ADDENDUM NO. 1

CITY OF ROLLA
TAXIWAY A RECONSTRUCTION AND TAXIWAY CONNECTOR REHABILITATION
at
ROLLA NATIONAL AIRPORT (VIH)
VICHY, MO

MoDOT Project # 23-056A-1

ADDENDUM NO. 1

UNDERDRAIN TRENCH SECTION (ADJACENT TO PAVEMENT) DETAIL

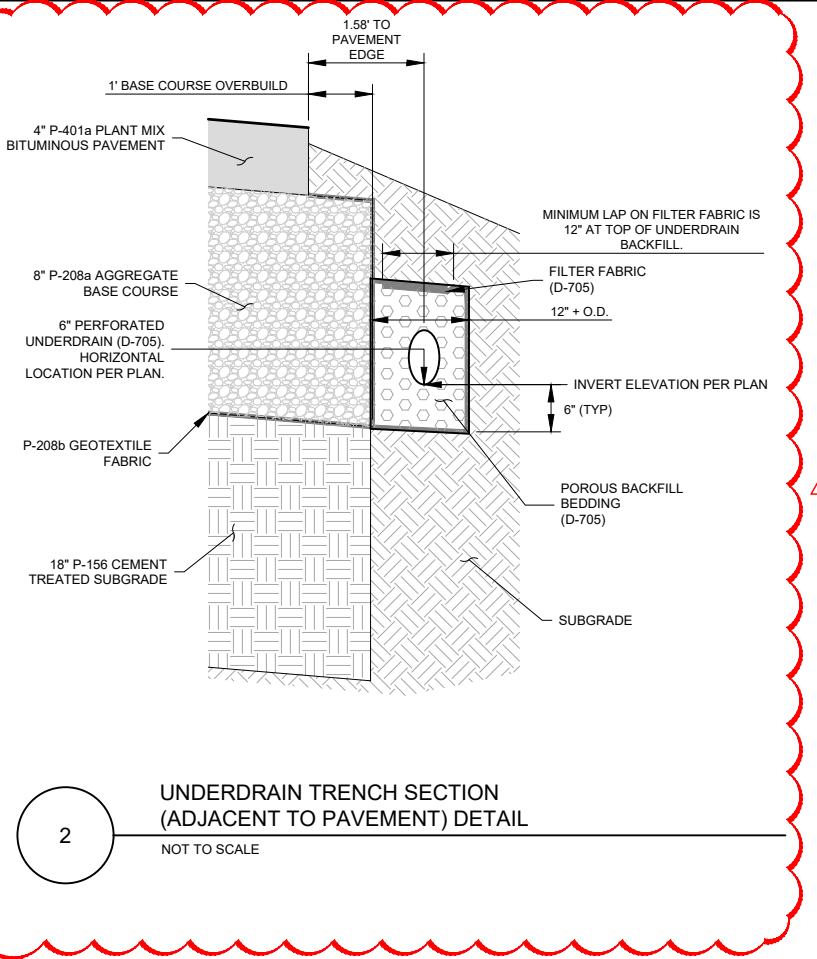
Revision: Updated Detail 2 *Underdrain Trench Section (Adjacent to Pavement) Detail*

Justification: This was revised to match the adjusted invert elevations.

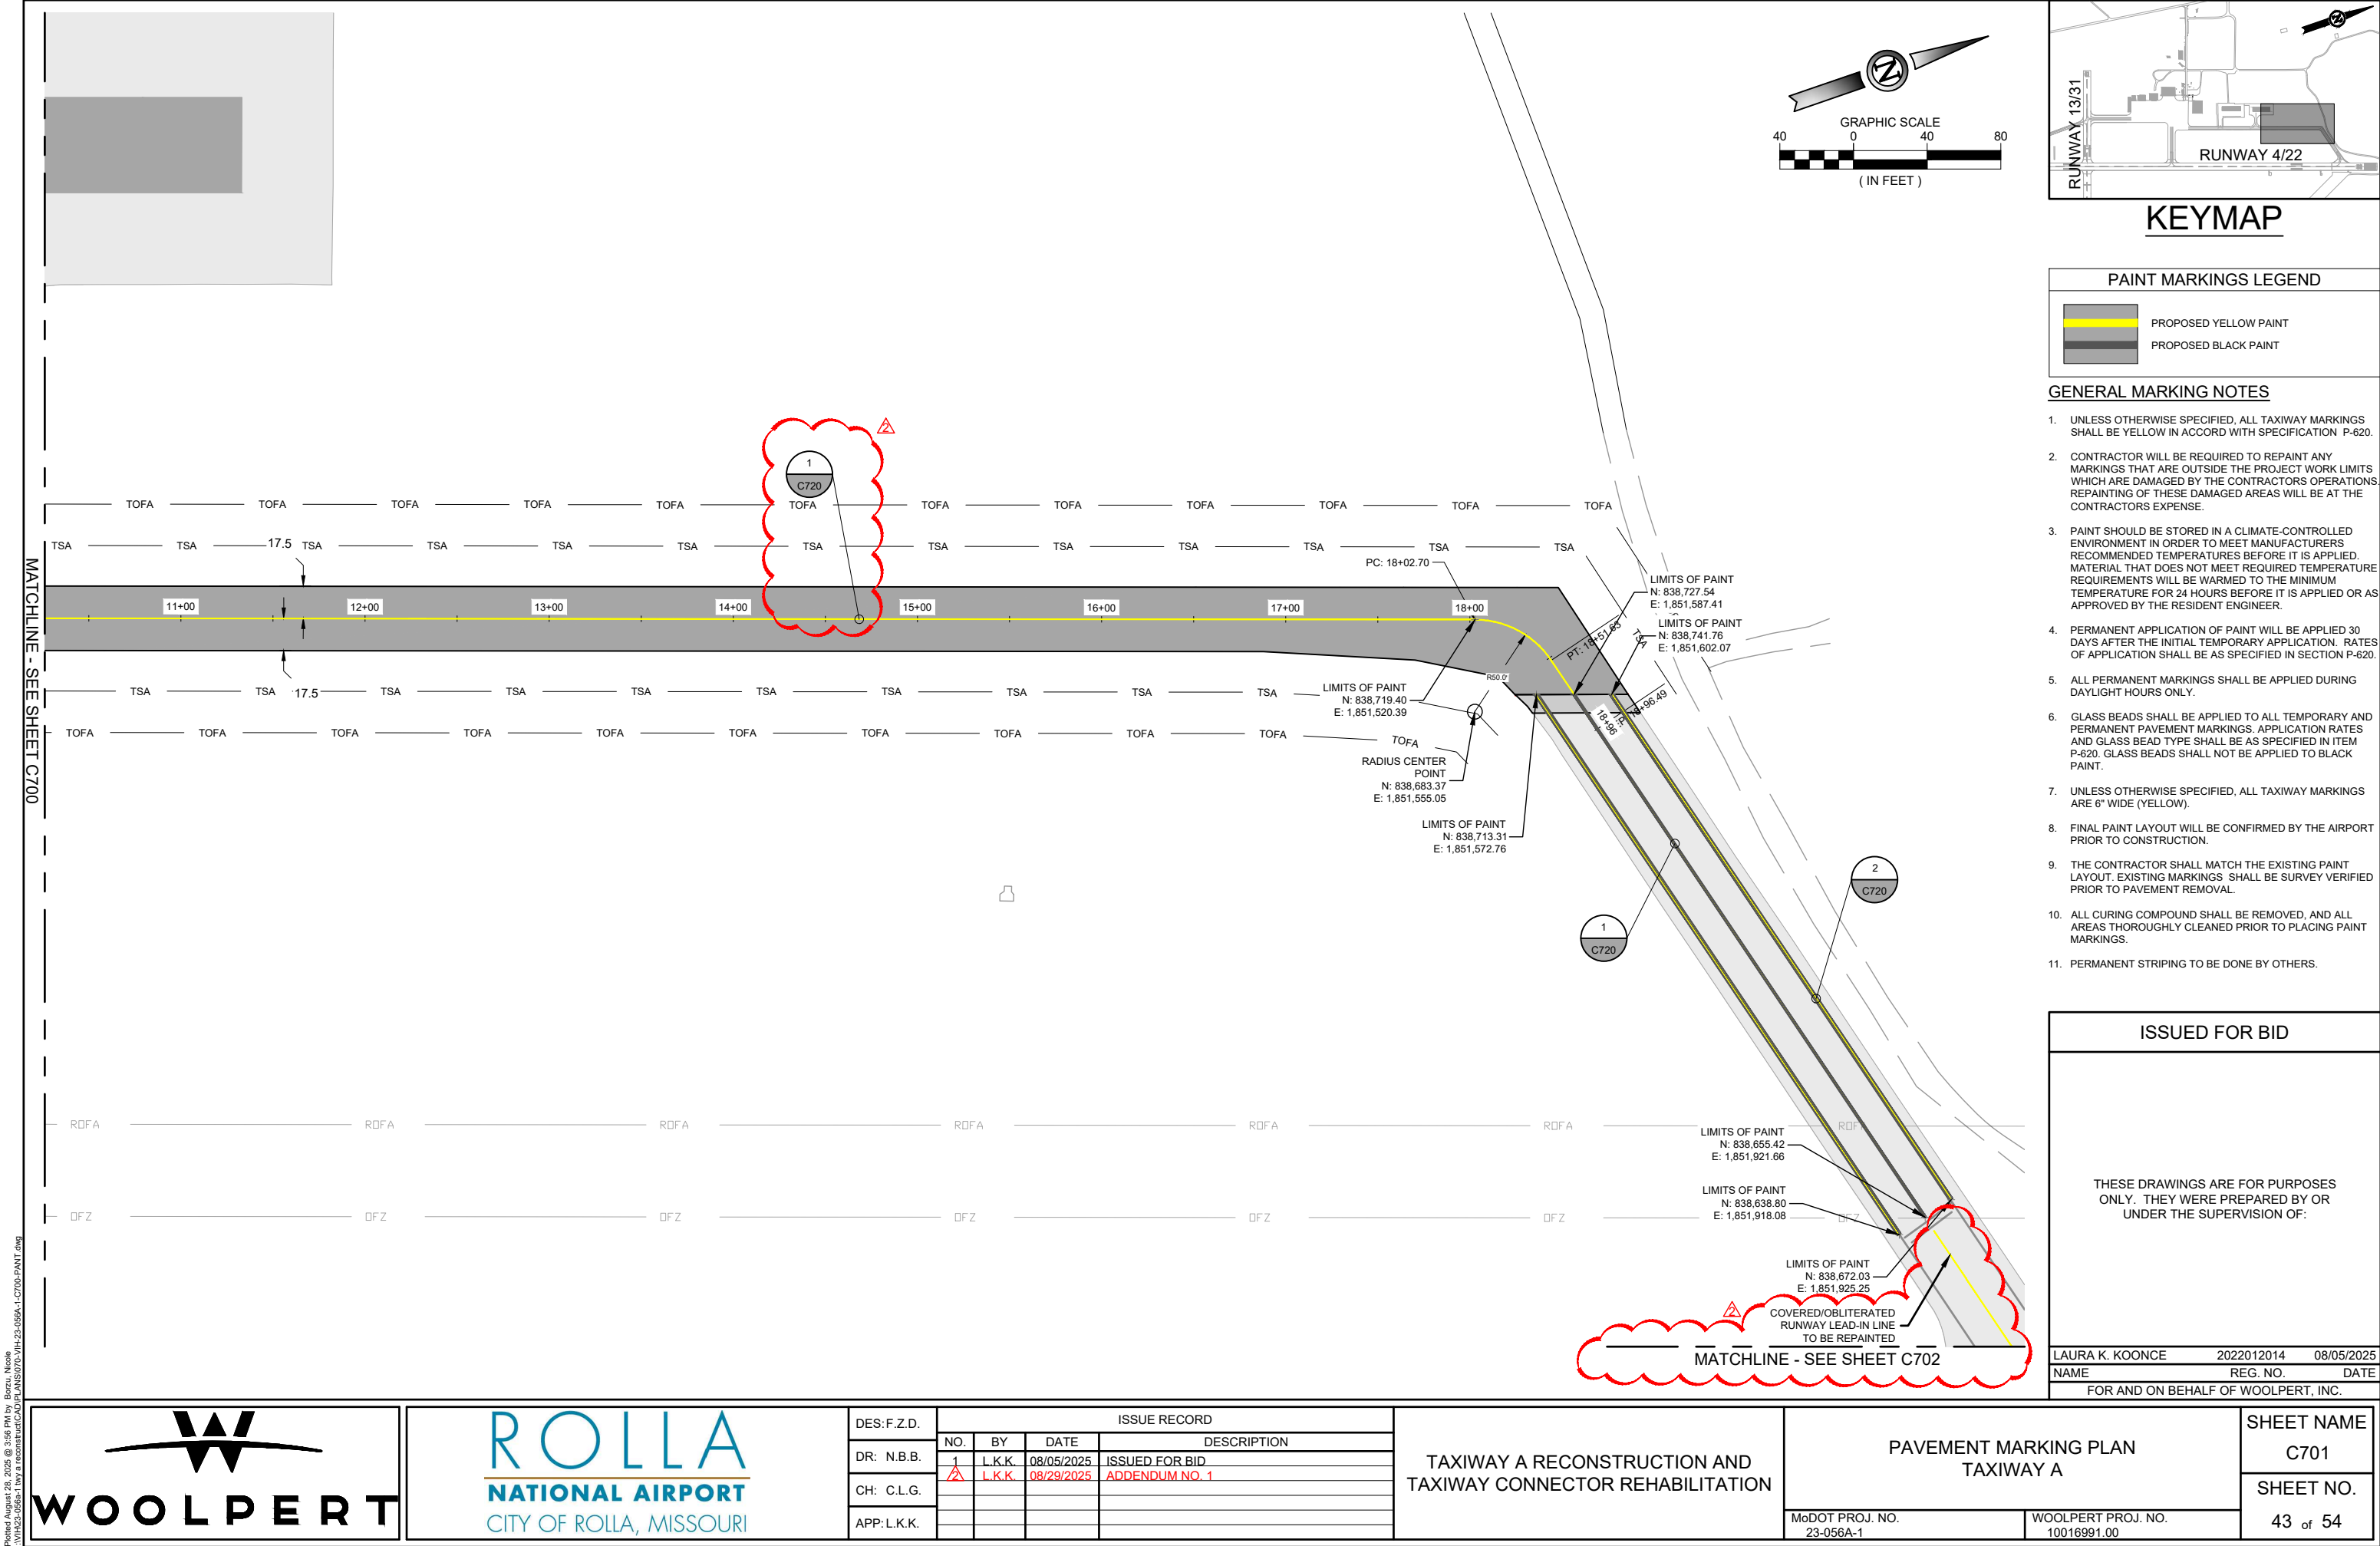
Revision: Updated reference to detail on sheet C720.

Revision: Added yellow paint for taxilane centerline between Taxiway A and the Taxiway Connector.

Justification: Detail 4 was removed because it was the same as detail 1.

Justification: This was added to show the repainting of the taxilane centerline which was obliterated/covered for construction.

SHEET NAME
C701

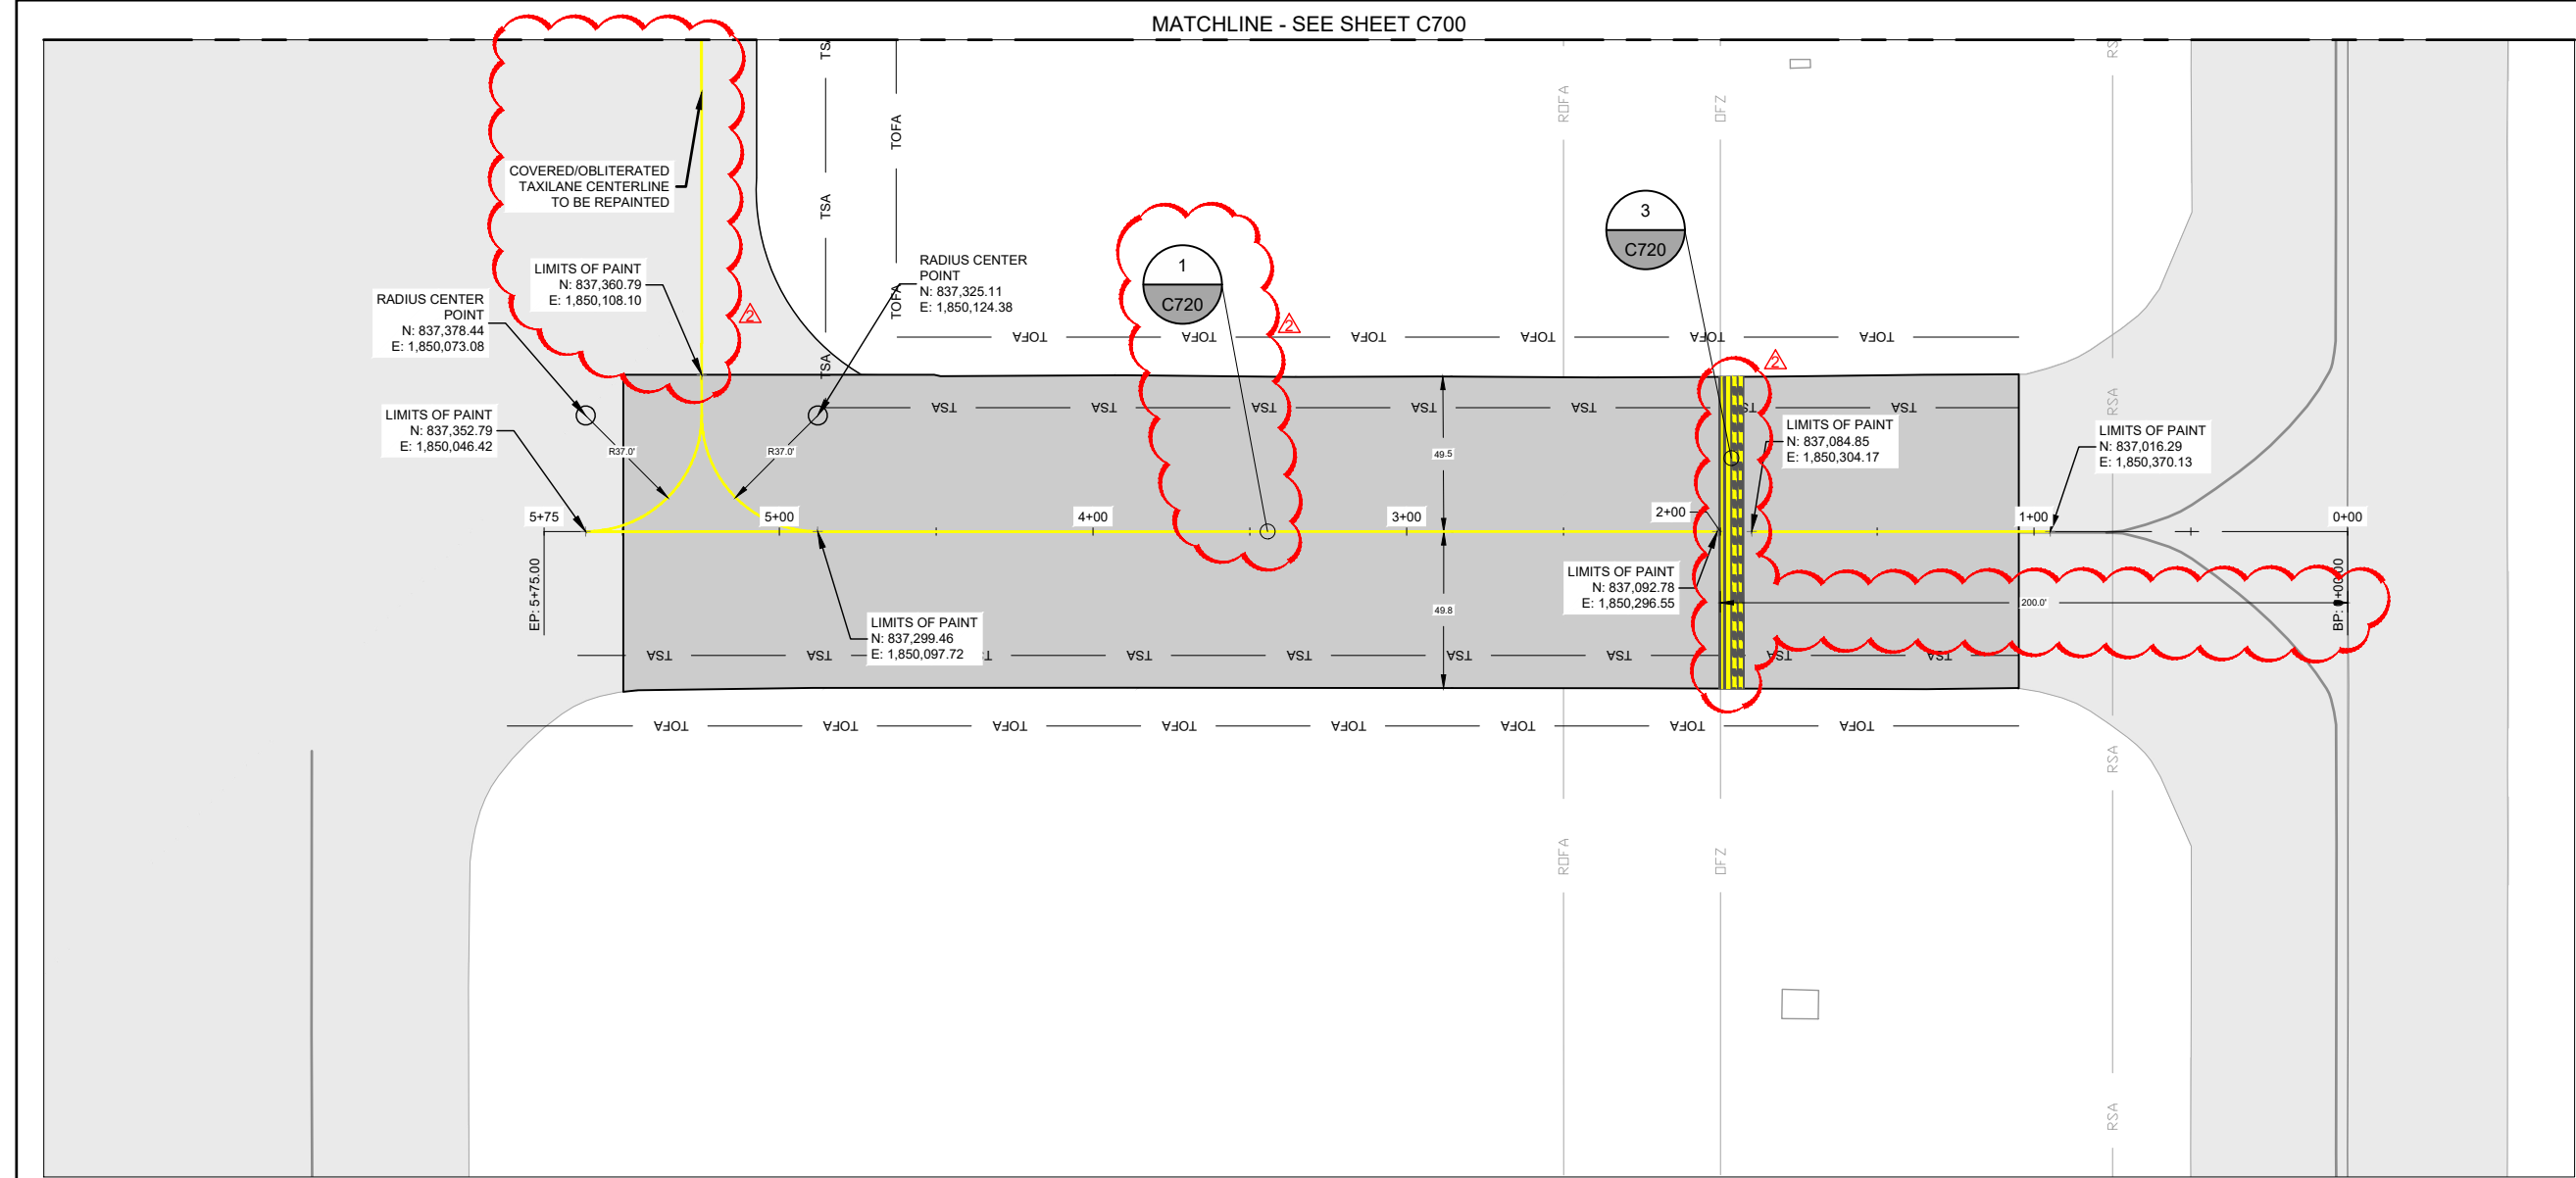
Revision: Updated reference to detail on sheet C720.

Revision: Added yellow paint for runway lead-in line from Runway 4/22 to Taxiway A.

Justification: Detail 4 was removed because it was the same as detail 1.

Justification: This was added to show the repainting of the runway lead-in line which was obliterated/covered for construction. A matchline referencing a viewport with the remainder of the lead-in line was also added.

PAVEMENT MARKING PLAN
TAXIWAY B CONNECTOR

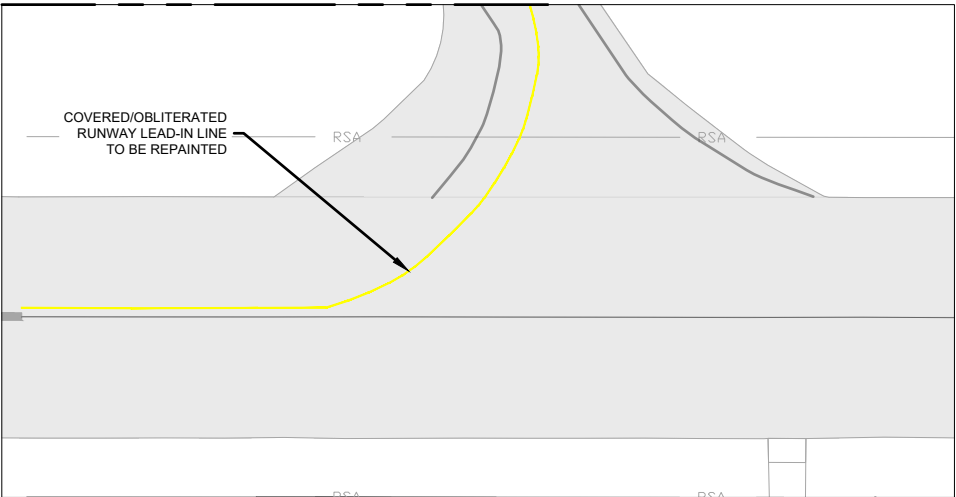
Revision: Updated reference to detail on sheet C720.

Revision: Added yellow paint for taxilane centerline between Taxiway A and the Taxiway Connector.

Revision: Added viewport for yellow paint runway lead-in line from Runway 4/22 to Taxiway A.

Justification: Detail 4 was removed because it was the same as detail 1.

Justification: This was added to show the repainting of the taxilane centerline which was obliterated/covered for construction.

Justification: A viewport and matchline were added to show the repainting of the runway lead-in line which was obliterated/covered for construction.

1 TAXIWAY CENTERLINE DETAIL
NOT TO SCALE
NOTE: BLACK BORDERS ARE NOT REQUIRED ON NEW ASPHALT PAVEMENT.

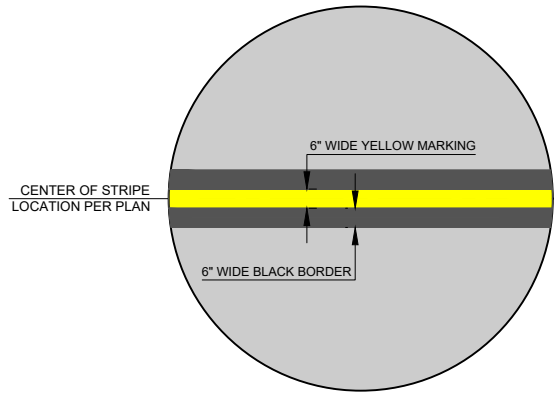
Revision: Added dimensions to black borders for details 1 and 2.

Revision: Added note to details 1 and 3.

3 RUNWAY HOLDING POSITION DETAIL
NOT TO SCALE
NOTE: BLACK BORDERS ARE NOT REQUIRED ON NEW ASPHALT PAVEMENT.

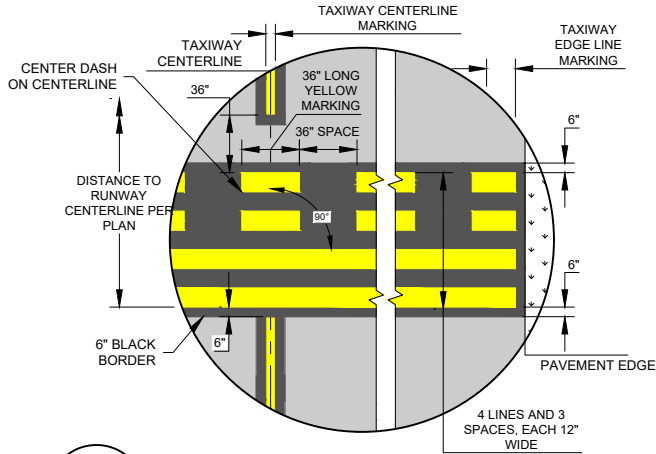
Revision: Added black paint to detail 3.

Justification: This is the correct detail. Refer to added note for paint on asphalt pavement.
